Access Compliance Report

Public Rights-of-Way

(Curb Ramps)

Intersection ID: 17262	Main Street: FLORENCE_AV	Cross Street: RAMA_RD	Location:	N
ADA ID: 3FB439AEF3A2	Ramp Type: PerpDiag	Initial Pass/Fail: Fail	Overall Compliance: No	Severity Score: 13.75
Codes/Mitigation Info/Possible Solution		Field Measurements/Component Compliance

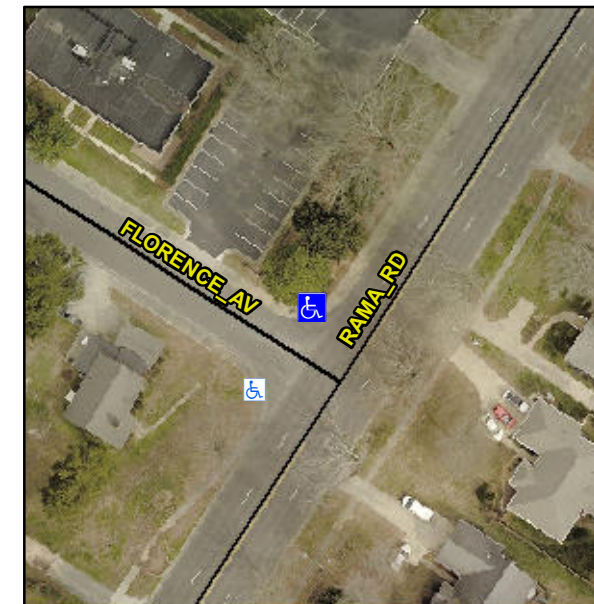
Not Found, R304.2.2, R304.5.3

Compliance	Description	Data	Compliance	Description	Data
N/A	Ramp Length (in)	61.0	No	Ramp Slope (%)	8.7
Yes	Ramp Width (in)	48.0	No	Ramp XSlope (%)	3.2
N/A	Flare Type LT	N/A	N/A	Flare Type RT	N/A
N/A	Flare Slope LT (%)	N/A	N/A	Flare Slope RT (%)	N/A
N/A	Flare Traversable LT?	N/A	N/A	Flare Traversable RT?	N/A
N/A	Landing Length (in)	N/A	N/A	DWS Provided?	N/A
N/A	Landing Width (in)	N/A	N/A	DWS Contrast?	N/A
N/A	Landing Slope (%)	N/A	N/A	DWS Length (in)	N/A
N/A	Landing X Slope (%)	N/A	N/A	DWS Full Width?	N/A
N/A	Landing Curb? (Y/N)	N/A	N/A	DWS Offset (in)	N/A
N/A	Shared Landing?	N/A			
N/A	Gutter Ponding?	N/A	N/A	Gutter Slope (%)	N/A
N/A	Gutter Lip Ht (in)	N/A	N/A	Gutter X Slope (%)	N/A
N/A	Painted X Walk1?	No	N/A	Painted X Walk2?	No
	X Walk 1 Direction	To SW		X Walk 2 Direction	To SE
N/A	X Walk 1 Width (in)	N/A	N/A	X Walk 2 Width (in)	N/A
	X Walk 1 Slope (%)	2.8		X Walk 2 Slope (%)	2.9
	X Walk 1 X Slope (%)	3.0		X Walk 2 X Slope (%)	3.5

Remove & Replace Curb Ramp With Two New Directional Ramps or Equivalent.
